Development Special Use Permit #2014-0019
1800 Mount Vernon Avenue

Purpose of Application
Approval of a Development Special Use Permit with site plan and modifications and a deviation to construct a residential mixed use building.

**DSUP #2014-0019, TMP SUP
#2015-0075
1800 & 1800 R Mount Vernon
Avenue**

Exhibit 1 Front façade on Mount Vernon Avenue

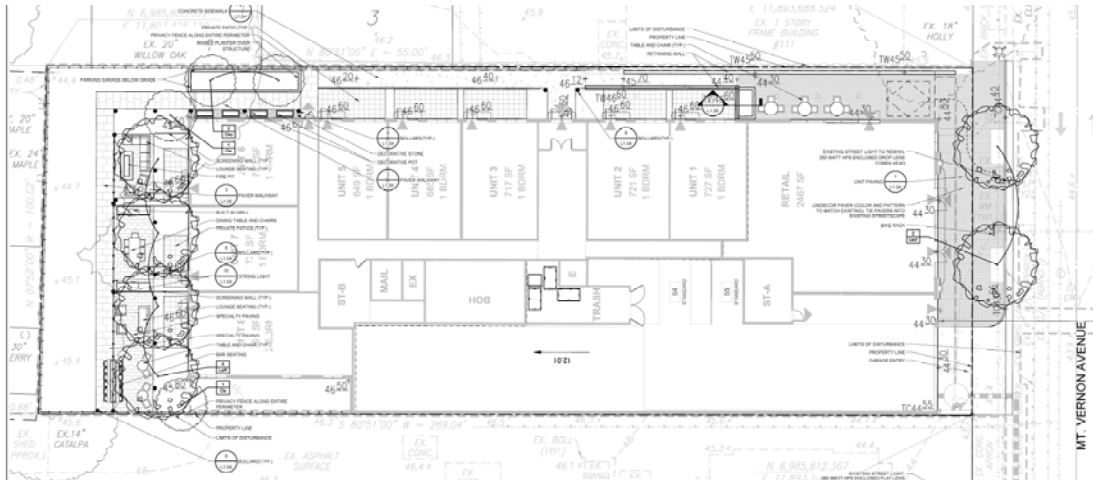
Staff, therefore, recommends that the existing carved stone façade features be carefully removed during the demolition of the building and incorporated into the façade of the proposed project, using the maximum amount possible of original material. Based on a site inspection, it appears to be feasible to preserve the frieze band, the center parapet detail, the pilasters and floral medallions. The elevation submitted with the Preliminary Plan shows the reuse of some of these elements on the front (east) façade facing the avenue. It is not necessary to use all of the original materials on the front façade; some may also be used at the building's entrance on the north elevation. The applicant should work with staff during careful deconstruction of the front façade to ensure that the building's character defining features are preserved to the greatest extent reasonably possible. Staff also recommends that the applicant introduce a recessed glass block feature in the lower portion of both entry pilasters on the front facade, from the stone base up to either the proposed canopy or the bottom of the second floor spandrel, to recall the feature that was part of the architect's original design but never constructed. The specific width, depth, detailing, and potential internal illumination of this feature will be determined during final site plan approval.

- b. All wall mounted vents shall be flush mounted and architecturally integrated with the building design with regard to placement and color.
 - c. Continue to work with staff on the integration of the existing building façade carved stone elements on the new building, unless determined not feasible by the Director of Planning and Zoning. Based on a site inspection, it is feasible that the frieze band, the center parapet detail, pilasters and floral medallions can be retained and reused.

- d. Work with staff, in the field, as the front façade is deconstructed to ensure the elements are preserved to the extent feasible.
 - e. Applicant shall work with City to introduce a recessed glass block feature element in the lower portion of both entry pilasters, from the stone base up to either the proposed canopy or the bottom of the second floor spandrel, to recall the feature that was originally part of the historic front façade. The specific width, depth and detailing of this feature to be determined during final site plan approval.
